SUBJECT: Revs to application for amend to Licenses NPF-10 & NPF-15,
 revising Tech Specs re cycle dependent values & power
 distribution limits. Marked-up Tech Specs encl.

Subject: Docket Nos. 50-361 and 50-362
San Onofre Nuclear Generating Station
Units 2 and 3

REQUIRED REVISIONS TO PCD NPF-10/15-52

REQUIRED REVISION TO PCD NPF-10/15-85

FIGURE 3.2-3 DNBR MARGIN OPERATING LIMIT BASED ON CORE PROTECTION CALCULATORS (CYCLE 2, COLSS OUT OF SERVICE, WITH RATED THERMAL POWER < 70%)

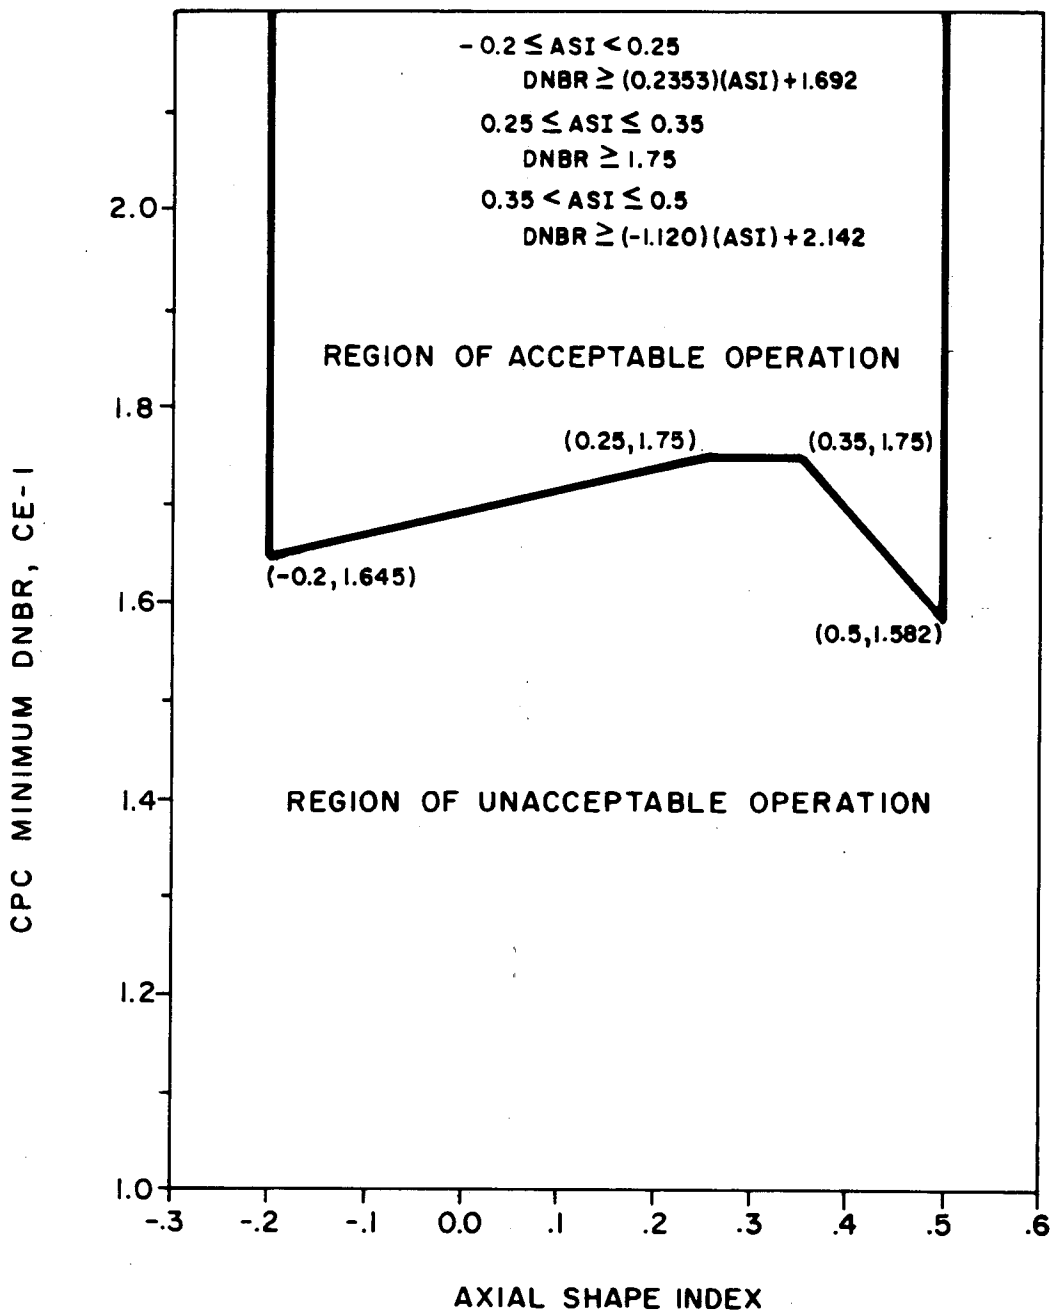
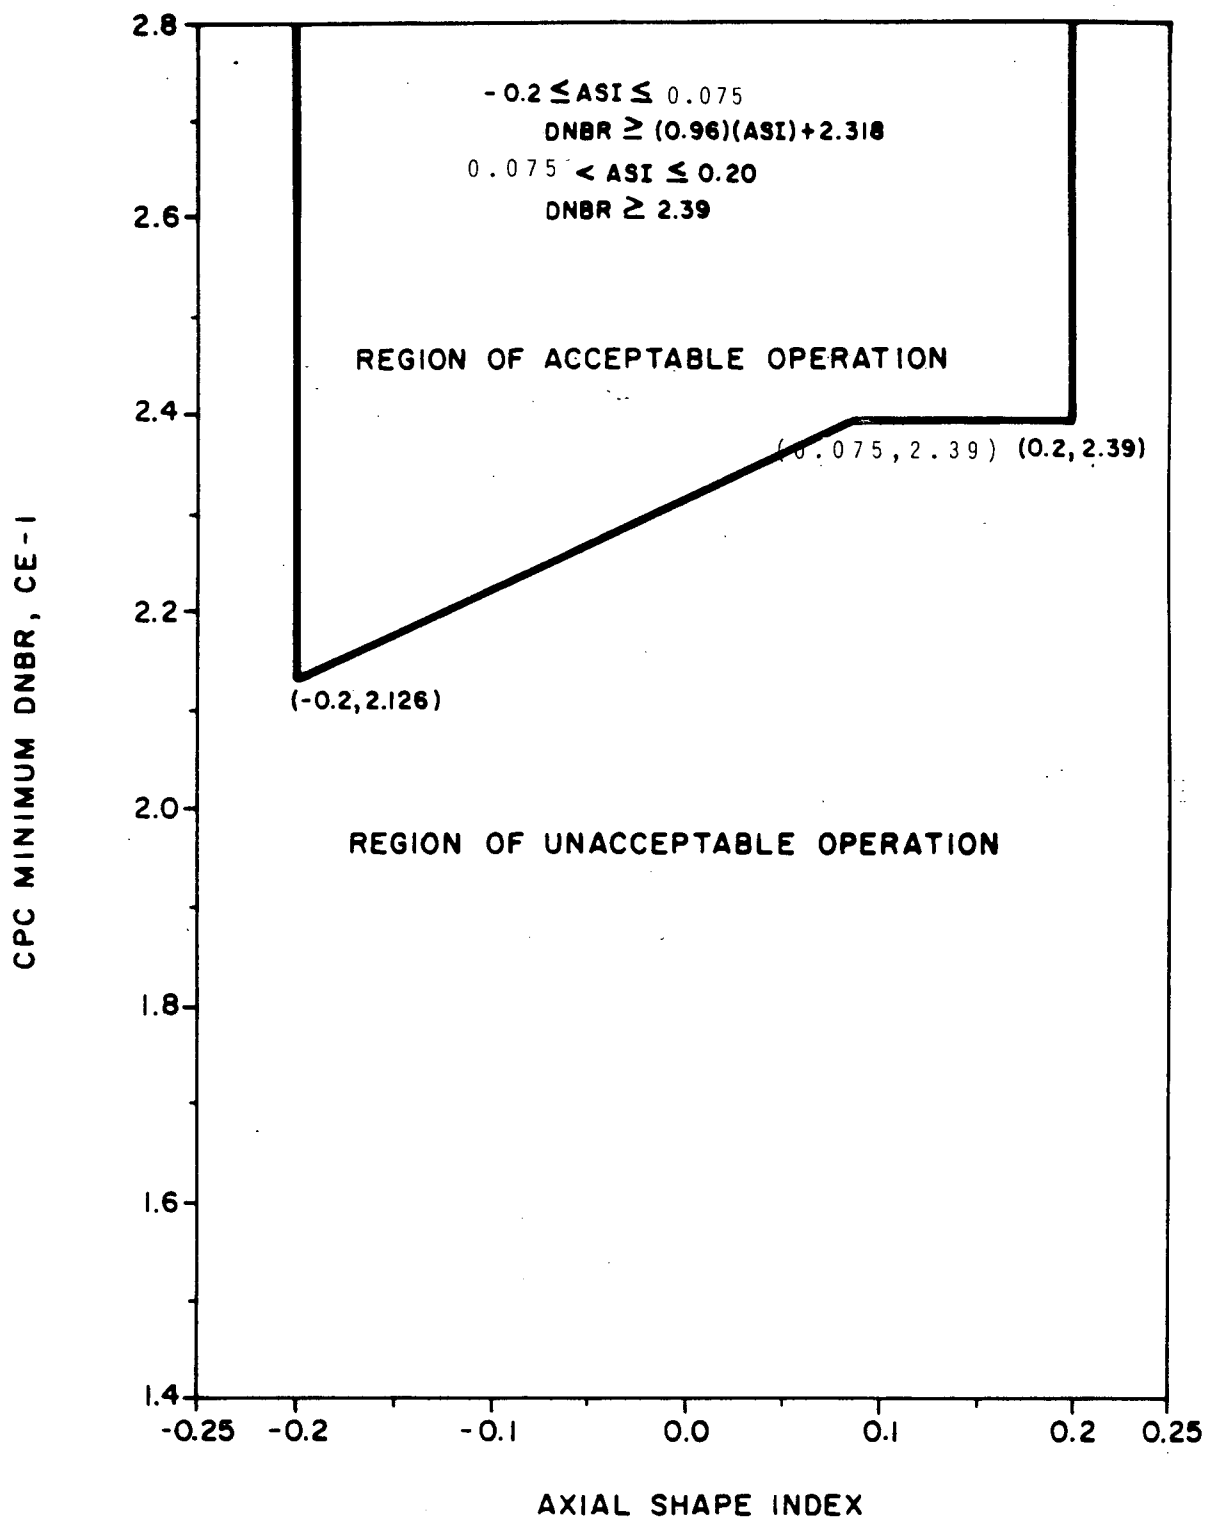
Figure 3.2-2, "DNBR Margin Operating Limit Based on Core Protection Calculators (COLSS out of service)," defines the region of acceptable plant operation when COLSS is out of service. Proposed Change NPF-10/15-52 splits Figure 3.2-2 into two new figures, 3.2-2 and 3.2-3. Figure 3.2-2 defines the region of acceptable operation for reactor power levels greater than or equal to 80% power. Figure 3.2-3 applies for reactor power levels less than 80%. The split was made to take advantage of lower measurement and calculational uncertainties at higher power levels thereby maximizing plant power capability when COLSS is out of service. In addition, both of the proposed Figures 3.2-2 and 3.2-3 incorporate a reevaluation of CPC uncertainties which resulted in a reduction of minimum required DNBR at all power levels. Both of the proposed Figures 3.2-2 and 3.2-3 are cycle specific and must be updated for Cycle 2. For Cycle 2, the breakpoint between the two figures is at 70% power rather than 80%, with Figure 3.2-2 applying for power levels greater than or equal to 70% and Figure 3.2-3 below 70%. Both figures have minimum DNBR requirements which are greater than their Cycle 1 counterparts. This increase in minimum DNBR requirements results from the CPC's providing a reactor trip on reactor coolant pump (RCP) speed for protection for the Loss of Flow (LOF) event in Cycle 2, rather than on the DNBR-flow projection used in Cycle 1. This change in the manner which CPC generates a loss of flow trip directly impacts the results of the Loss of Flow transient analysis, which is the limiting Anticipated Operational Occurrence (AOO) in determining margin requirements at full power. Because COLSS, when in service, reserves the required margin in terms of underflow fraction to account for margin degrading during the LOF transient, additional margin must be reserved in Figures 3.2-2 and 3.2-3, when COLSS is out of service.

The proposed change splits Figure 3.2-2 into two new figures, 3.2-2 and 3.2-3. Figure 3.2-2 defines the required minimum DNBR for reactor operation at greater than or equal to 80% power. Figure 3.2-3 defines the minimum required DNBR for reactor power levels of

less than 80%. The current Figure 3.2-2 is split into two new figures in order to take advantage of lower measurement and calculation uncertainties at higher powers which result in a reduction of the minimum DNBR requirements at higher powers. In addition, in both of the proposed Figures 3.2-2 and 3.2-3 a reevaluation of CPC uncertainty has reduced the minimum DNBR requirements by approximately 10% at all power levels. Thus, under the proposed change, when COLSS is out-of-service, the plant will be able to operate at a higher power level (i.e., with lower minimum DNBR). These Figures 3.2-2 and 3.2-3 are applicable only to Cycle 1 operation. A second Figure 3.2-2 and 3.2-3 are added which are applicable to Cycle 2 operation. In Cycle 2, Figure 3.2-2 is applicable at powers greater than or equal to 70% (versus 80% in Cycle 1) and Figure 3.2-3 is applicable below 70%. In Cycle 2, both figures require higher minimum DNBR than is currently required by either the existing T.S. or the proposed Figures 3.2-2 and 3.2-3 for Cycle 1. This results from changes in the manner in which CPC's will generate a reactor coolant low flow trip in Cycle 2. To accommodate this CPC change, more margin must be reserved in Figure 3.2-2 and 3.2-3 to provide the same level of protection against a loss of flow event, the limiting anticipated operational occurrence.

included in the CPC calculations are not included in the DNBR margin Figures 3.2-2 and 3.2-3, since these figures are intended to apply during steady state operation.
